75 Lawn Road, London, NW3 2XB  
Application Ref. (2018/3428/P)

## RESPONSE TO CONSULTEE COMMENTS

September 2018

*Comparison between existing garage set back from the front elevation at 72-75 Lawn Road*

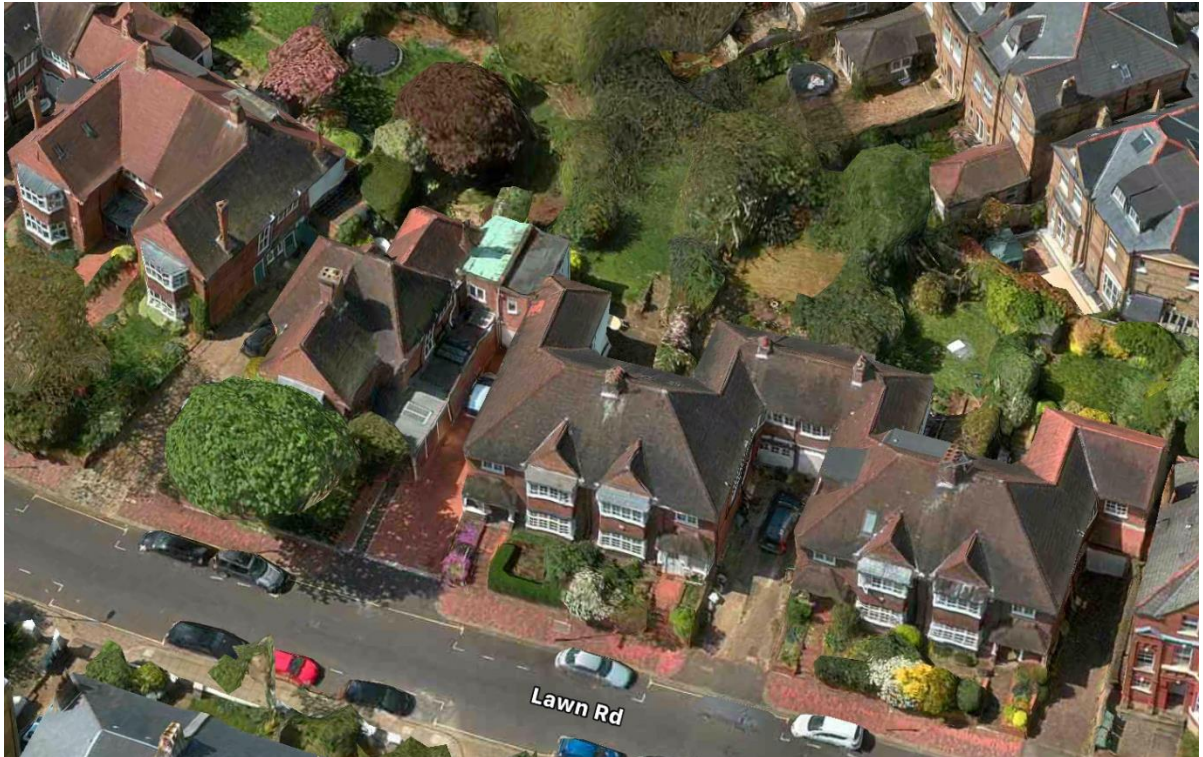
- a) The '*mansard roof on the side extension*', stating it, '*destroys the symmetry of the 2-story side extensions observed from the public highway*' and will '*create the only example along the row of 1920s Arts & Crafts style houses where the 1<sup>st</sup> floor side elements of two adjacent houses are not flush with each other (i.e. in the same vertical plane)*', and '*would look incongruous from the street*'.
- b) The '*front dormer*', as it '*would set a precedent*'
- c) the size of the 2m front first floor extension '*is not a modest extension*'

- 2.9. The existing two-storey garage blocks at Nos. 72, 73 & 74 are set back from their front elevations by between approximately 9m, 9.2m and 9.3m respectively (see below diagram).

- 2.10. The existing garage block at 75 Lawn Road is set back from the front elevation of the property by 12.28m. The proposed first floor extension is 2m forward of the existing garage, giving a set back of 10.28m. This modest extension will therefore enable No.75 to better reflect the prevailing relationship between side elements and front elevations of both its pair at No.74, and that of its adjacent linked pairs at Nos.73 & 72 Lawn Road.

*Extract from section B-B showing extent of 2-storey pitched rear extension in relation to existing property outlines in purple.*

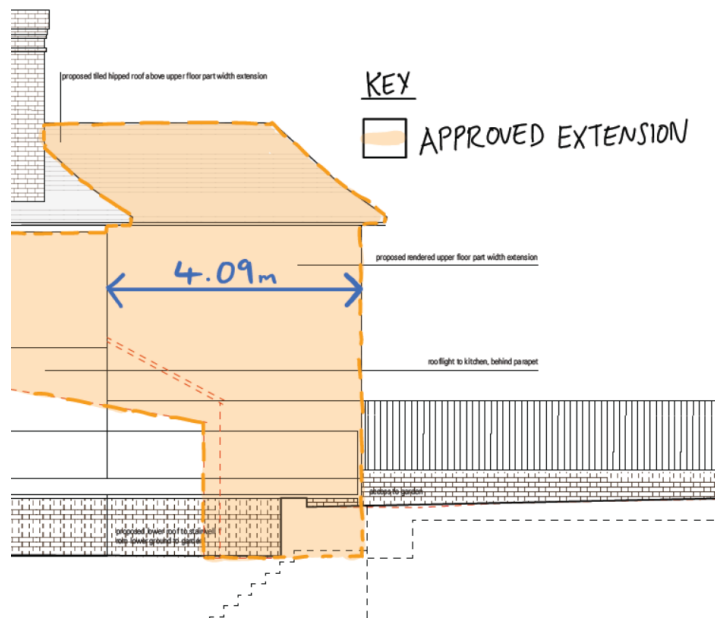
- o 'the proposals are too large and dominate the original house'

- o The *'bulk, scale and mass'* of the rear extension, stating, *'it would not be subordinate to the existing dwelling, and would harm the character of the existing dwelling and the surrounding conservation area'*.

- 3.1. The proposed 3.61m two-storey rear extension is a continuation of the existing rear wing of the house, with matching ridge, eaves and pitch. As such, the proposal remains subservient to the main 'host building'.

*Computer Generated Image of front first floor window above garage at No.76 Lawn Road with window frame shown translucently. This image shows that the extension will not 'create a tunnel effect.'*

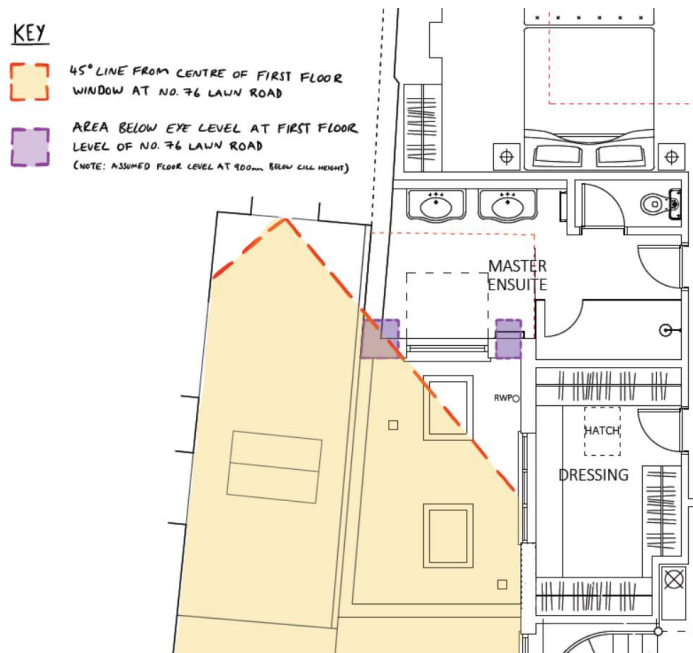
- being ‘overbearing’
- creating a ‘sense of enclosure’, with the resident at No.76 adding that the new 2 metre projection ‘will create a tunnel effect’.

Whilst the proposed side extension will be visible from No.76’s first floor bedroom window, this impact is considered minimal as it will only obstruct views of the flank wall of No.75 Lawn Road (see below visualisation).

Extract showing extent of proposed rear extension which will be no closer to No.74 than the existing flank wall.

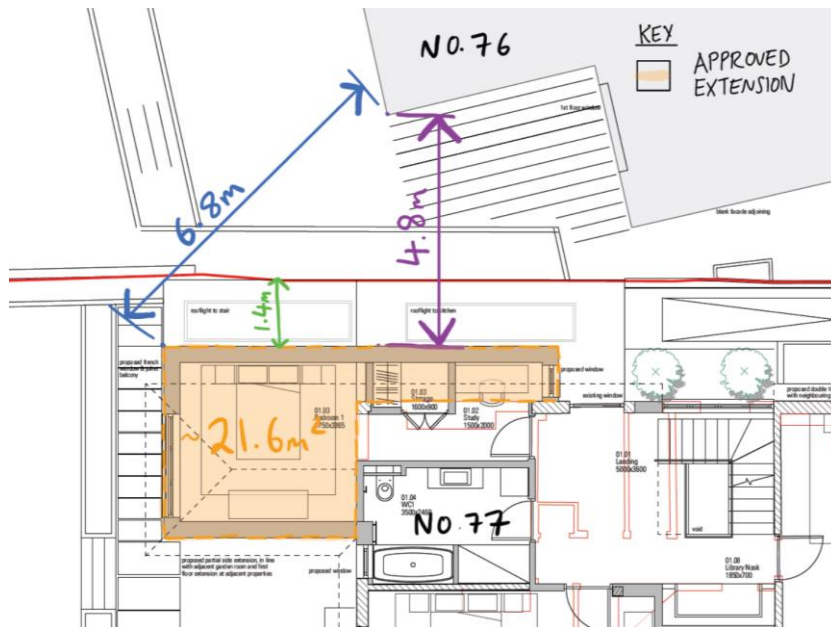
- the rear extension’ ‘causes a [...] significant loss of amenity to the adjoining neighbour at no.74’
- and ‘causes a regrettable sense of enclosure’

- 4.9. The existing flank wall of no. 75 is 4.09m from the boundary wall with No. 74, and 7.4m from No.74's rear flank wall. The position of the flank wall of No.75 is not altered in the proposed development.
